RINCON HILL PLAN DRAFT EIR—COMMENTS AND RESPONSES

This document contains public comments received on the Draft Environmental Impact Report (Draft EIR, or DEIR) prepared for the proposed Rincon Hill Plan, and responses to those comments. Also included in this document are staff-initiated text changes.

Figure R-1
 Revised Preferred Option
 (115-Foot Tower Separation)

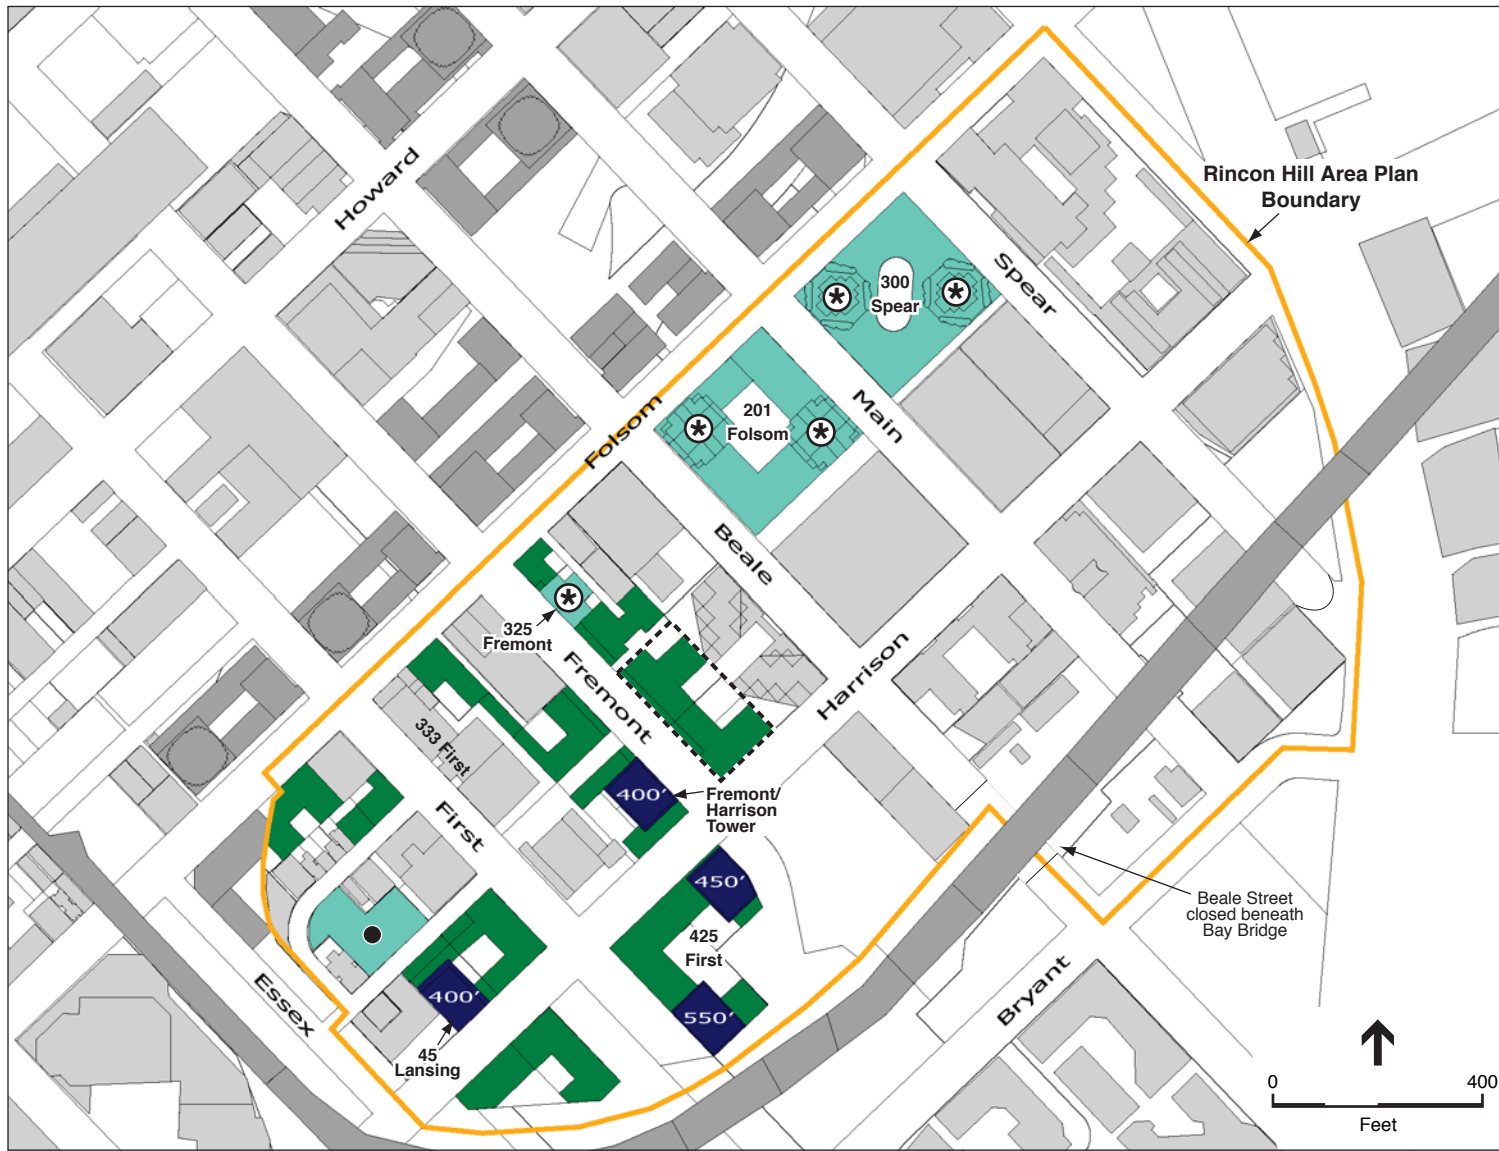
The second important revision concerns the proposed residential towers at 375 Fremont Street (Case No. 2002.0449) and 399 Fremont Street (Case No. 2003.0169). During the January 27 presentation, staff recommended that these two projects, which have been under review by the Department since 2002 and 2003, respectively, be allowed to proceed under one of two approaches: either 1) that the two projects be “grandfathered” under the Draft Plan (i.e., the projects would continue to be processed under the existing Rincon Hill Area Plan and existing Rincon Hill Special Use District zoning regulations (which would allow the project sponsors to seek exceptions to the minimum 150-foot tower spacing, rezoning, maximum floorplate controls, and other exceptions from the Planning Commission); or 2) that the sponsors of the two proposed projects jointly develop a proposal for a single tower on the two sites combined into one. Under this second approach, staff indicated its intent was that the proposed single tower at the 375-399 Fremont site would be sized such that the project would contain an equivalent number of residential units to that which has been proposed for two separate projects combined.

If a single tower is built at 375-399 Fremont Street, it would be constructed on a single joined parcel at approximately the location indicated in DEIR Figure 8, p. 23 of the DEIR, which illustrates the 82.5-foot Option. Although potentially taller than the 300-foot building assumed in the 82.5-foot Option (the height would be limited to no more than 400 feet), a single tower at 375-399 Fremont would not have any impacts that would be substantially greater than those described in the DEIR for the 82.5-foot Tower Separation Option, in that the overall number of units and density of structures would be similar. The taller single tower at 375-399 Fremont would result in incrementally greater shadow and visual impacts; however, visual impacts would be within the envelope described in the EIR by the combined photosimulations of the 82.5-foot/Extended Pipeline Option, with the exception that the taller single tower accommodation would have fewer towers than depicted in those simulations, although one tower would be as much as one-third taller than shown in the simulations (in the 82.5-foot/Extended Pipeline Option simulations this taller tower would be essentially the same height as the 400-foot-tall Fremont/

The following text is added to the end of DEIR p. 17 to acknowledge the revised Preferred Option:

Subsequent to publication of the DEIR, Planning Department staff recommended that the Preferred Option be revised to allow one additional tower up to 400 feet in height on the site of two currently proposed smaller towers, 375 Fremont Street and 399 Fremont Street. The potential ramifications of this revision are discussed in Chapter VIII, Comments and Responses, beginning on p. C&R-5.

Figure R-2
Potential Development Sites

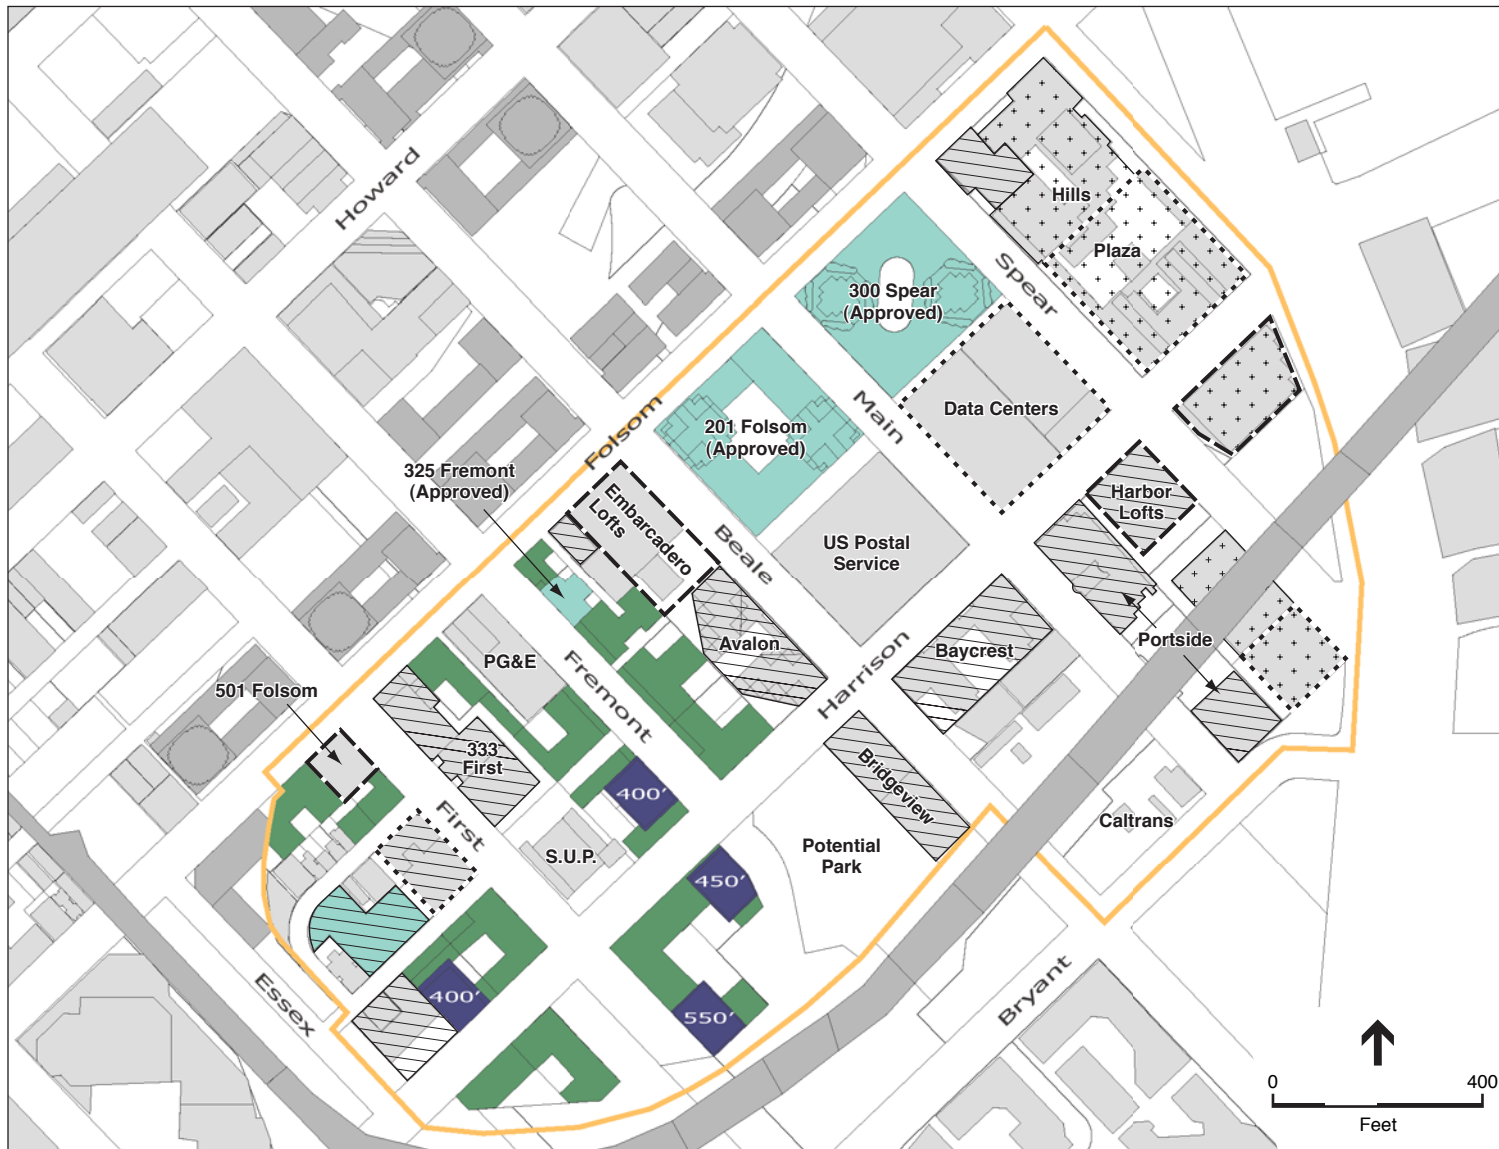
A number of commenters, including planning commissioners and members of the public, made comments in regard to the Draft Plan’s proposal to “eliminate the discretion” of the Planning Commission in its approval of tower within the Plan area, and specifically with regard to the Commission’s discretion, exercised since the Rincon Hill Area Plan was initially adopted in 1985, to permit the distance between tower (tower separation) to be less than the existing Area Plan’s required 150 feet. At the November 29, 2004, public hearing on the DEIR, each of the seven planning commissioners explicitly stated that they opposed the elimination of Commission discretion in the consideration of individual projects. Several members of the public also urged the Commission not to approve a plan for Rincon Hill that would eliminate such discretion, both in writing and at the public hearing. (*Planning Commissioners Alexander, Antonini, Bell, Hughes, S. Lee, W. Lee, and Olague; Lucian Robert Blazej, Strategic Solutions; Debra H. Stein, President, GCA Strategies; Richard H. Kaufman, President, City-Core Development, Inc; W. Stephen Wilson, Tobin & Tobin; Aaron Poser; Robert McCarthy, McCarthy and Schwartz*)

As can be seen in Figure R-2, the potential development sites described in the DEIR’s discussion of Visual Quality impacts (p. 84) “would be concentrated in the area fronting on Folsom Street, Fremont Street between Folsom and Harrison Streets, and on Harrison Street, between Fremont

Figure 1 (Revised)
Project Location

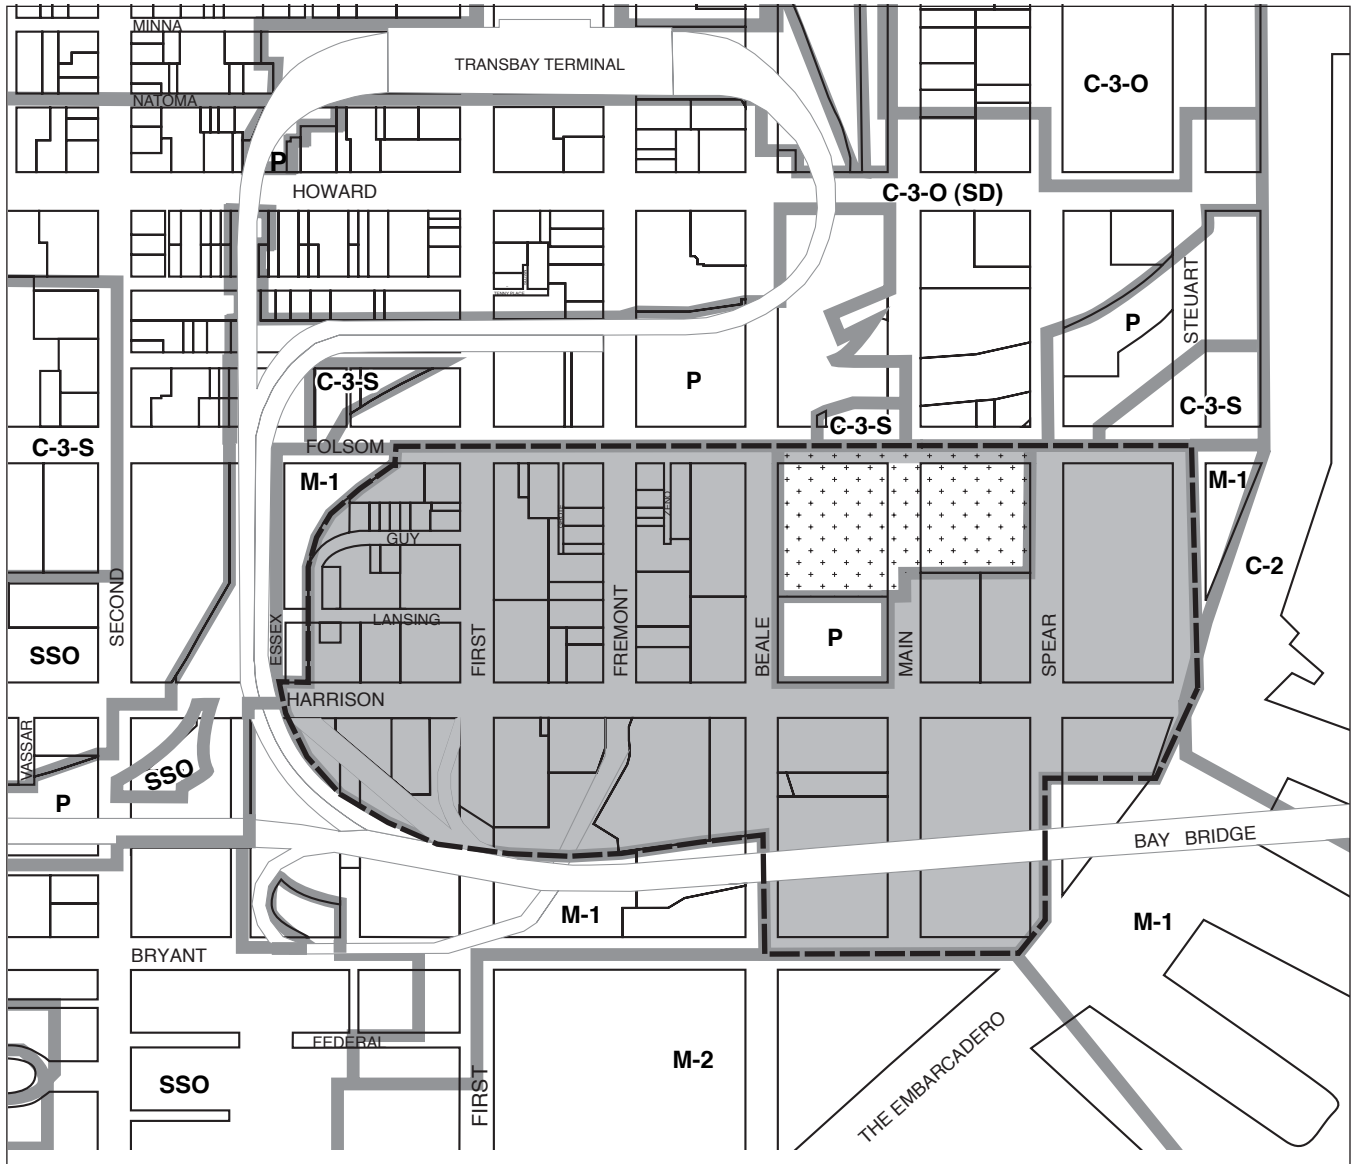
Page 5, Figure 1, and all other maps in the EIR: The maps incorrectly show Spear Street connecting to The Embarcadero. Spear Street is a cul-de-sac south of Harrison Street that does not connect to The Embarcadero. Also, all the maps show Beale Street connecting Folsom and Bryant Streets. As pointed out on page 127, Beale Street has been closed underneath the Bay Bridge for more than three years. (*Jerry Robbins, San Francisco Department of Parking and Traffic*)

The maps in Figure 1 (Project Location) and in Figures 7, 8, and 9 (Plan options) have been revised to incorporate the comments and are included in Section D of this document, Staff-Initiated Text Changes. The revised maps will be included in the Final EIR. It is noted that this results in no change in physical impacts, as both the text and the analysis assumed the closure of Beale Street and the existing configuration of Spear Street.

On page 5, Figure 1 has been revised to indicate the closure of Beale Street beneath the Bay Bridge, and to indicate that Spear Street does not intersect the Embarcadero, but instead ends in a cul-de-dac (the revised figure is at the end of this section).

Figure 5 (Revised)
Proposed Height Districts

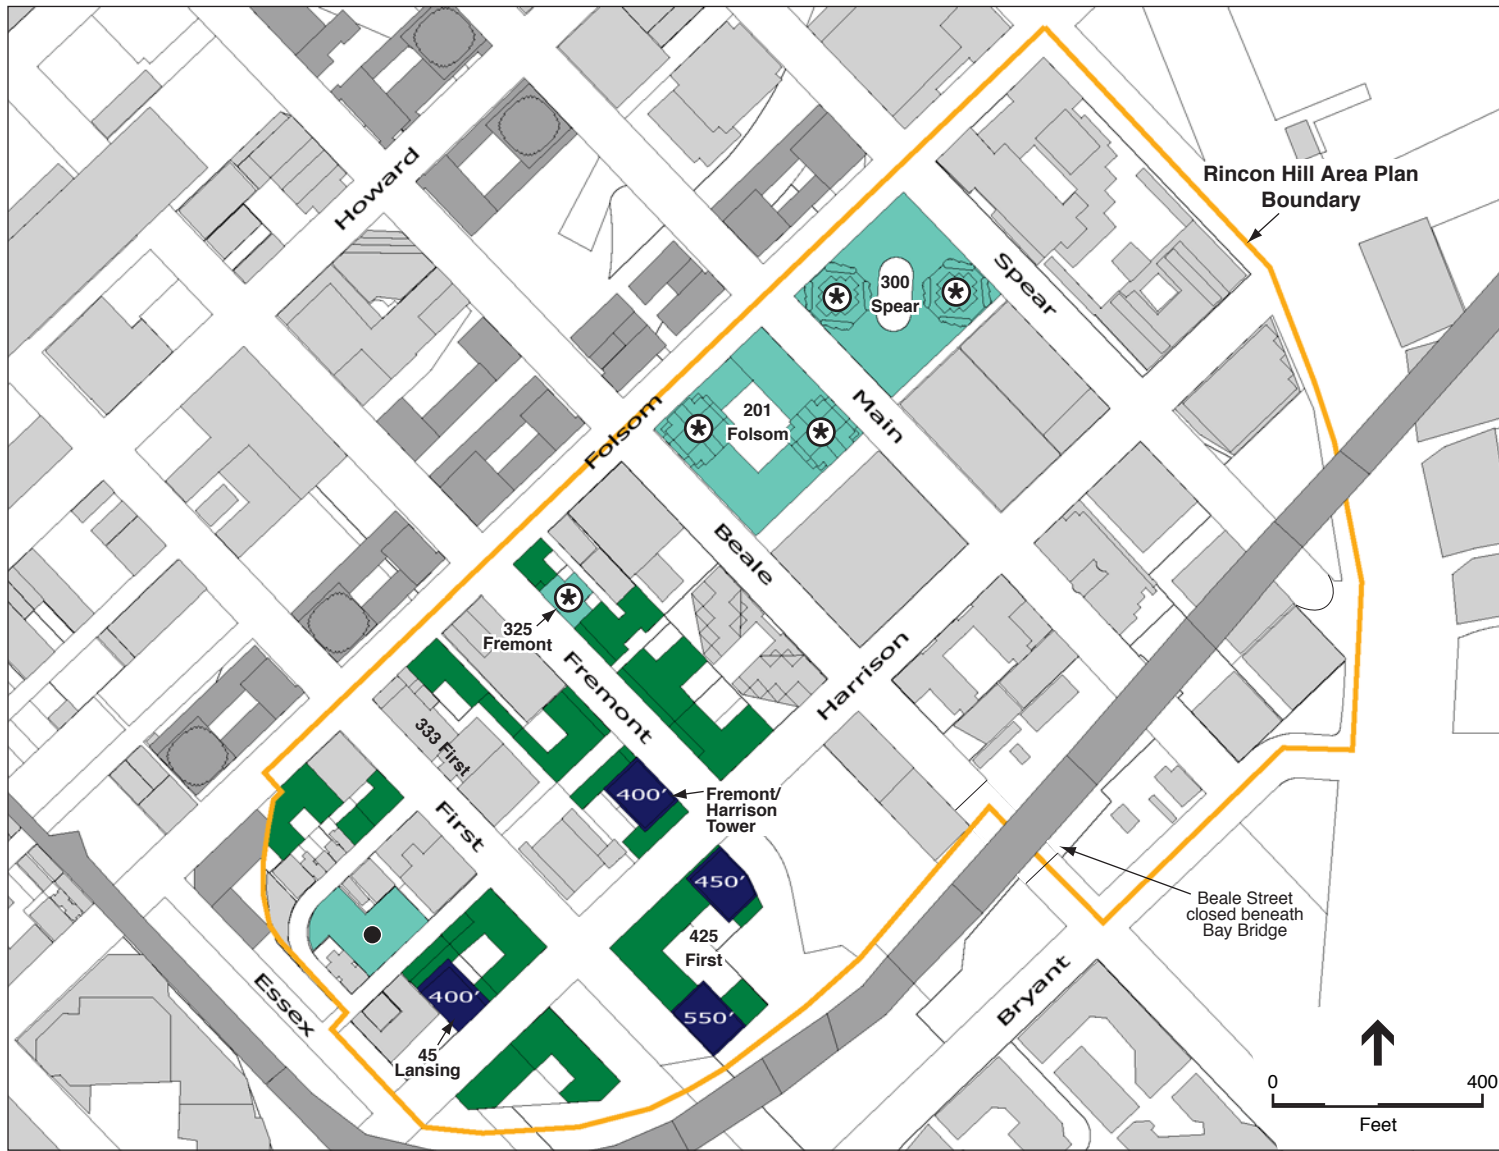
Regarding the proposed height limits in Figure 5, it is true that buildings could not be built to the maximum height limit on every site because of the requirement for separation of towers, just as this is true under the existing Rincon Hill Area Plan. The proposed tower separation requirements, like the existing tower separation requirements, would become part of the Planning Code if they are adopted. East of Beale Street and south of Folsom Street, as well as east of Spear Street and north of Folsom Street, height limits are generally proposed at 85 feet under the

On page 11, Figure 5, Proposed and Bulk Districts, is revised with the following changes (the revised figure is at the end of this section):
